WBN-TS-99-014

WATTS BAR NUCLEAR PLANT (WBN) UNIT 1 - TECHNICAL SPECIFICATION
(TS) CHANGE NO. WBN-TS-99-014 - STEAM GENERATOR ALTERNATE REPAIR
CRITERIA FOR AXIAL OUTSIDE DIAMETER STRESS CORROSION CRACKING
(ODSCC) - RESPONSE TO REQUEST FOR ADDITIONAL INFORMATION - (TAC
NO. MA8635)

WATTS BAR NUCLEAR PLANT UNIT 1 PROPOSED TECHNICAL SPECIFICATION CHANGE WBN-TS-99-014 ALTERNATE REPAIR CRITERIA (ARC) PRESSURIZATION RATE ISSUE RESPONSE TO NRC REQUEST FOR ADDITIONAL INFORMATION

Figure 1: Repeat of Figure 3.8 of the TVA report.

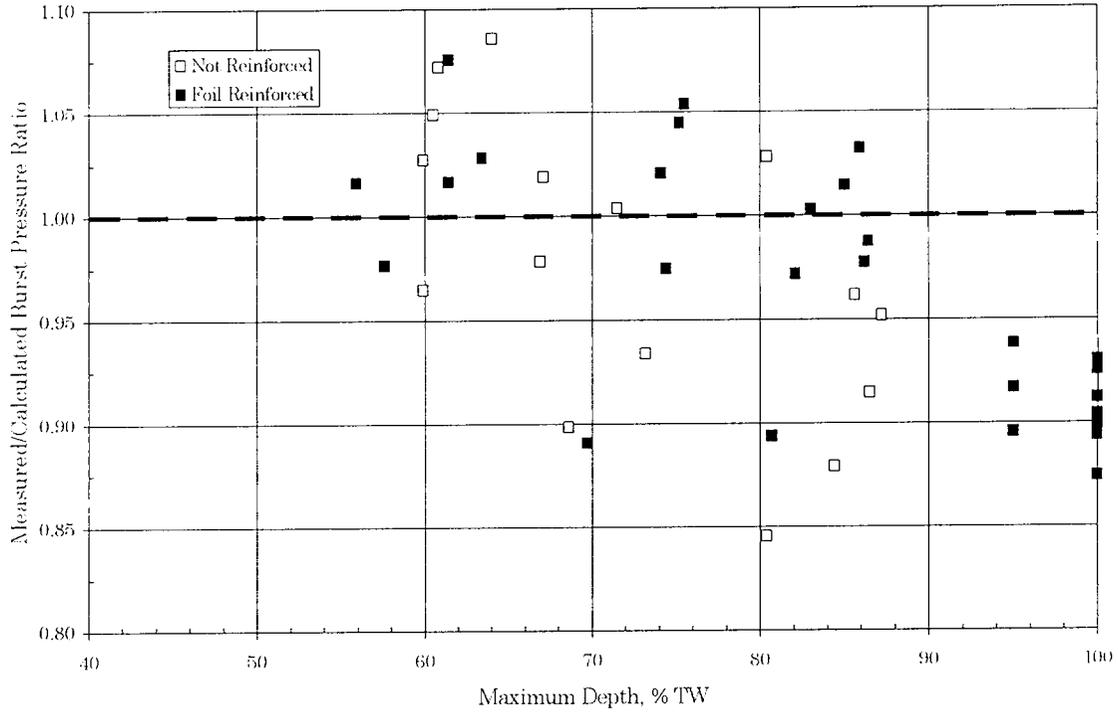
For Figure 3.8 of Enclosure 3, which was derived from Table 3-1, please address the following:

- a. For the indications with maximum depths between approximately 65% and 85%, the predictive model underpredicted the burst pressures for specimens tested without foil. In Enclosures 3 and 4, it was indicated that the Cochet equation may overpredict the burst pressure of partial through-wall cracks that do not end in full thickness material. In addition, it was indicated that the Cochet equation provides a conservative prediction of the burst pressure. Please address whether the underprediction for the 65% to 85% through-wall specimens tested without the foil is attributed to the limitations of the Cochet equation (related to cracks that do not end in full thickness material) or some other mechanism. If the underprediction is due to this effect, wouldn't it be more appropriate to compare the mean of the data for a specific depth (or a small depth range) for those specimens tested without a foil to the mean of the data for the same depth for those specimens tested with a foil to assess the effect of a foil for this specific geometry? If this were done, would it

alter the conclusion that a foil effect is being observed and/or its magnitude?

- b. Given the scatter in the burst pressure data for any given depth (approximately 5 to 10% in the burst pressure), discuss whether normalization of the data (to a mean curve) is appropriate and/or whether more testing needs to be performed to reach the conclusions drawn in the report.

- c. The staff notes that the tests depicted in Figure 3.8 were performed at slow pressurization rates and the tests indicating a foil effect were done at fast pressurization rates. These latter tests compared "fast-foil" tests to "slow-no-foil" and "fast-no-foil" tests. See Question 4.

A copy of Figure 3.8 is included as Figure 1 of this document. A review of the figure does effect a comparison of the means of the foil and no foil tests across the full range of depths. It is also apparent that there is a trend for the model to over estimate the burst pressure for the deeper specimens regardless of the presence of a foil reinforced bladder during the test, i.e., the data trend downward from left to right on the figure. A clearer comparison is apparent from an examination of Figure 3.7 of the report, which is included herein as Figure 2 for your convenience. Figure 2 illustrates the results from both models against an ideal prediction line and shows the results of performing a linear, 1st order regression analysis of the measured burst pressures on the predicted burst pressures. It is apparent from the figure that neither the slopes nor the intercepts are significantly different when separate regression analyses are performed for the no-foil and foil data.

The use of any normalizing equation leads to the conclusion that "the systematic deviation from the prediction model (Cochet or ANL) is the same for foil and no foil specimens." In other words, there is no detectable foil effect in the TVA specimens, and that finding extends to the ODSCC database because of the length of degradation involved.

The results of the tests were normalized using standard industry models, and thus could be concluded to have been normalized appropriately. The scatter of the data is not more pronounced than for other strength models employed, hence, more testing does not need to be performed to reach the conclusions expressed in the report.

The response to this issue is provided following Question 3 above. The important consideration here is with regard to the ODSCC ARC database, which consists of steam generator and laboratory tube cracked specimens with axial lengths and depths that in the extreme are comparable to the TVA test specimens. Results from "slow-foil" tests are not considered necessary to the resolution of the pressurization rate effect. Moreover, the test results for the TVA specimens demonstrate that any foil effect that might be implied by the results of the tests of the Type 14 specimens is not meaningful to the results of tube support plate ODSCC structural integrity tests.

Figure 1: Pressure vs. time history for a different specimen.

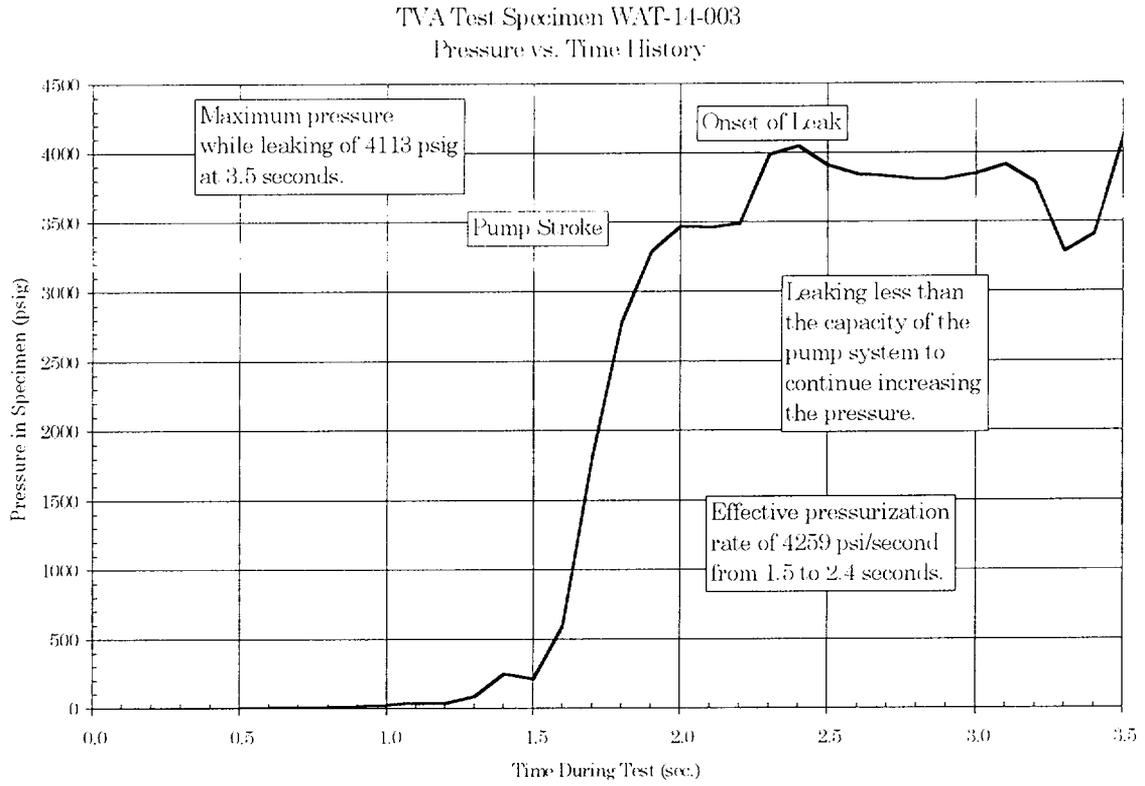
Figure 2.3 of Enclosure 3 represents a typical pressurization rate curve for the fast pressurization tests performed without the foil (this figure is actually a pressurization rate curve for a leak test). A review of this figure indicates that the pressurization rate prior to leakage was only on the order of 300 psi/sec rather than 2000 psi/sec. As a result, it appears to draw into question the conclusion that there is no pressurization rate effect. The subsequent test of this tube would have been performed with a bladder and a different flaw geometry.

If the plot in Figure 2.3 is typical, it is not apparent that the results truly represent "fast pressurization rate tests without a foil" rather they may represent slow tests without a foil.

The inclusion of the pressurization rate figure for specimen WAT-14-001 as typical was not intended to imply that the rates for the specimens were identical. In fact, the figure illustrates the rate for the slowest tested specimen. The data on the figure show that the overall average pressurization rate for the specimen was about 1191 pounds per square inch per second (psi/s), i.e., the pressure started to increase at 1.8 seconds and reached 4044 psi at 4.9 seconds. For the pressure range from 3500 to 4044 psi the rate was about 454 psi/s, the lowest pressurization rate of any of the Type 14 models tested. Table 2 in Enclosure 1 of this letter, provides a listing of the salient pressure and time information from the records for each of the Type 14 specimens. The average rate ranged from a low of 1191 psi/s to a high of 6472 psi/s. Also listed in Table 2 are the ratios of the measured maximum pressure to the predicted maximum pressure for each model, which demonstrates that the ratios were not dependent on the rate of the test, e.g., the fastest test had the lowest ratio. Figure 1 of this enclosure illustrates the pressure versus time history for a specimen that had an effective pressurization rate in excess of 4000 psi/s. Figure 2 of this enclosure illustrates the pressure versus time history for the

Figure 3: Comparison of the onset of leak pressure to the pressurization rate.

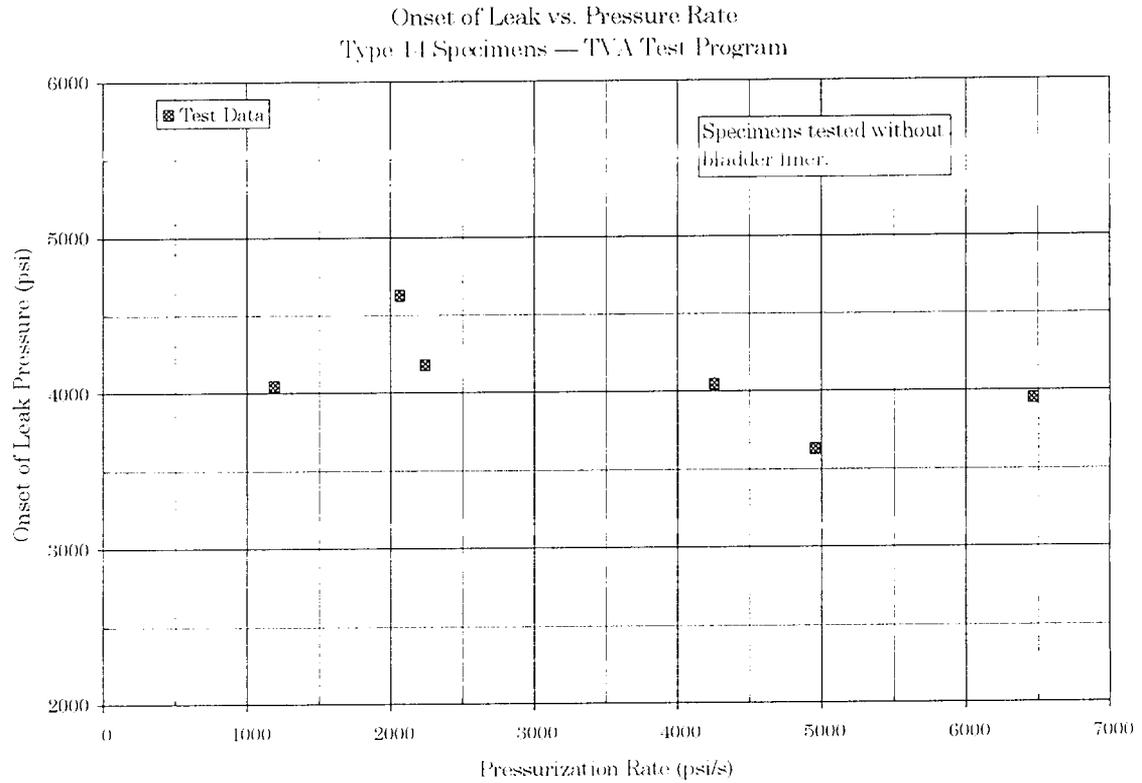
In light of the above, discuss the need to conduct slow pressurization rate tests with a foil so that a direct comparison of pressurization rates can be performed.

specimen tested at the fasted rate. For the specimens shown in these figures it should be noted that the rate near the end of the test was similar to the average rate during the whole test. Finally Figure 3 of this enclosure illustrates a chart of the onset-of-leak pressure as a function of the pressurization rate, convincingly showing that the pressurization rate did not influence the ligament tearing pressure of the specimens. The implication is that slow pressurization rate tests of specimens with a foil reinforced bladder liner are not needed.
